Subject: Docket number 29547: 207 Minute Extended Range  
Operations with Two-Engine Aircraft (ETOPS) Operation  
Approval Criteria

## Additional Boeing Observations

Boeing has had an opportunity to review the comments received by the FAA during the comment period for 207 Minute ETOPS (Docket No. 29547). In our view, many of the comments are not germane to 207 minutes in the North Pacific. Additionally, some of the comments include inaccuracies about Boeing airplanes, factual errors or misrepresentations. Boeing submits the following for purposes of clarification and accuracy.

Figure 1

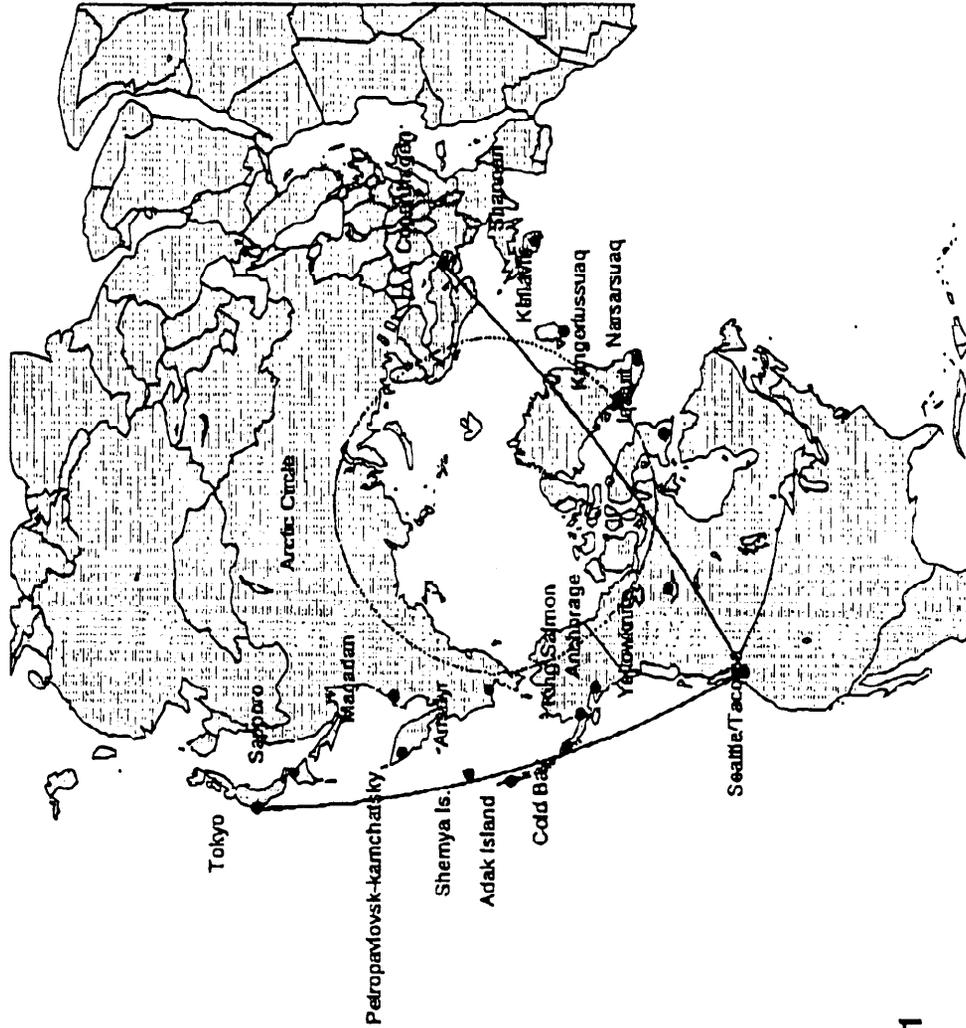
The North Pacific has about the same number of alternate airports as the North Atlantic, where ETOPS has been flown since 1985 (see Figure 1 on Page 16). Out of the seven or eight (depending on the type of airplane used, airline preferences) alternate airports available between Anchorage and Sapporo, just one is needed to fly the Pacific under 180-minute ETOPS rules. In fact, one Canadian airline performs non-ETOPS twinjet operations across the Pacific under special authorization from its regulatory agency that permits it to span the very small gap of a few minutes' flying time separating the 60-minute diversion radii of two of its en route airports.

- The Seattle-Tokyo Great Circle route does not go as far north as the Seattle-Copenhagen route
- One European airline has been operating Seattle-Copenhagen with the 767 since 1990.
- On the Seattle-Tokyo route, all the en route alternates except Anadyr are south of Anchorage.
- Anadyr is at about the same latitude as Iqaluit, a widely used North Atlantic alternate airport.
- The most northerly Seattle-Tokyo flights typically overfly Anadyr.
